orbit_demo review notes: issues, trade-offs, questions, discrepancy register

Package section 09_review_notes of orbit_demo_design_review, written 2026-10-06. Links are relative to this file. Paths in backticks without a link (reports/..., build/..., site/..., viz/..., docs/research/..., ORFS image paths) are repository, build or tool-image paths in /home/user/chip that are not copied into the package, unless a package copy is linked next to them or listed in [README.md](#) under How the package was built. "repo" = /home/user/chip.

0. Revision covered

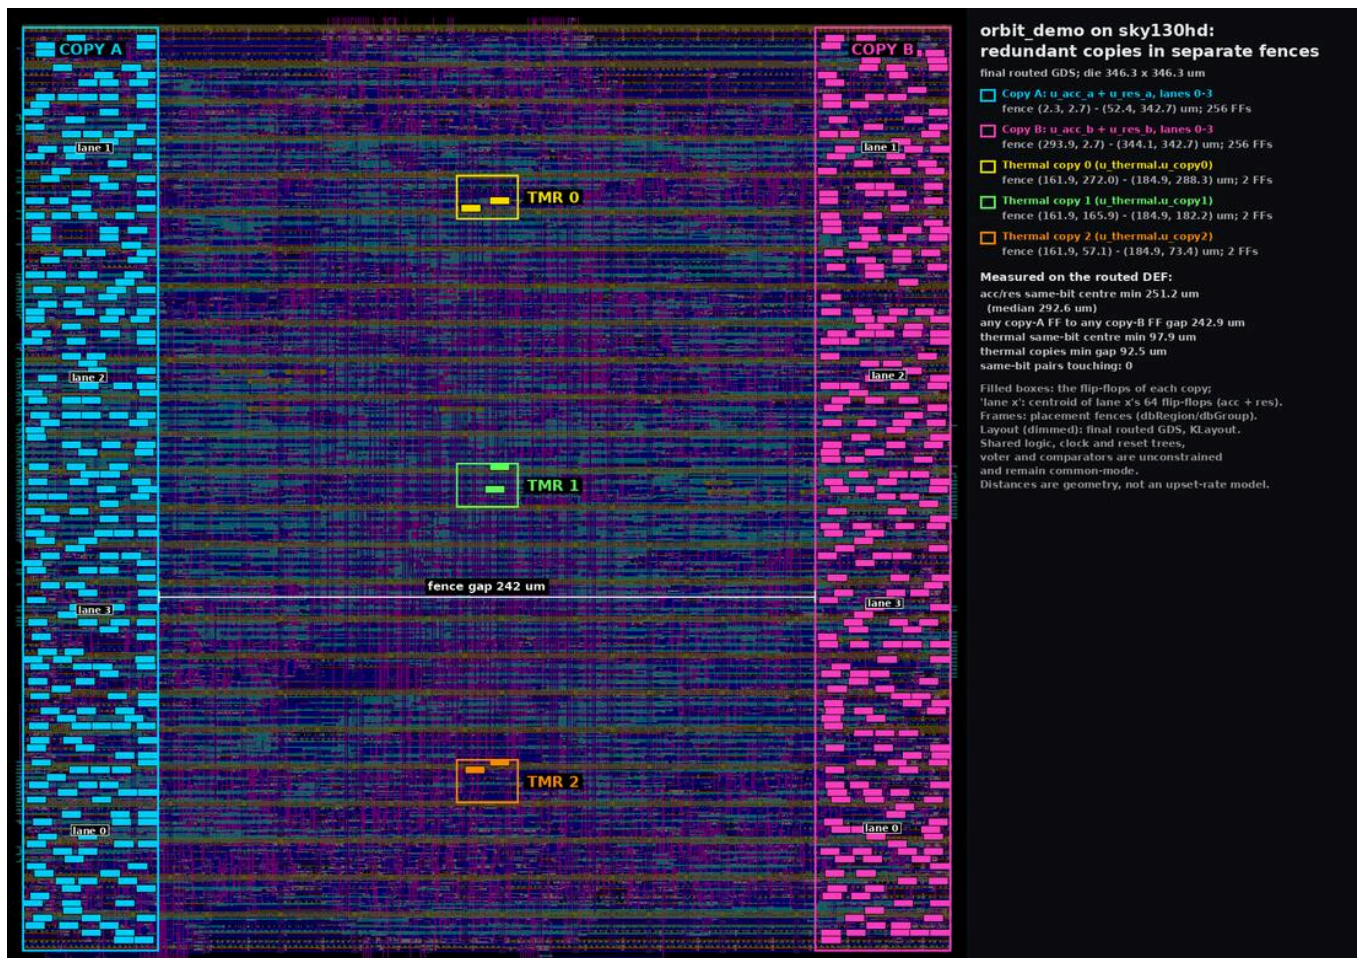
Figure 1. Routed sep GDS (KLayout render by `scripts/pdsep_render.py`, published as [orbit_demo_sky130hd_sep.png](#)). Copy A and copy B fences at the die edges, thermal fences TMR 0-2 in the centre column. Everything between the fences (multipliers, adders, comparators, OR-tree, voter, clock and reset trees) is shared (K-02). The "fence gap 242 um" label rounds the measured 241.50 um (D-13). Status: VERIFIED.
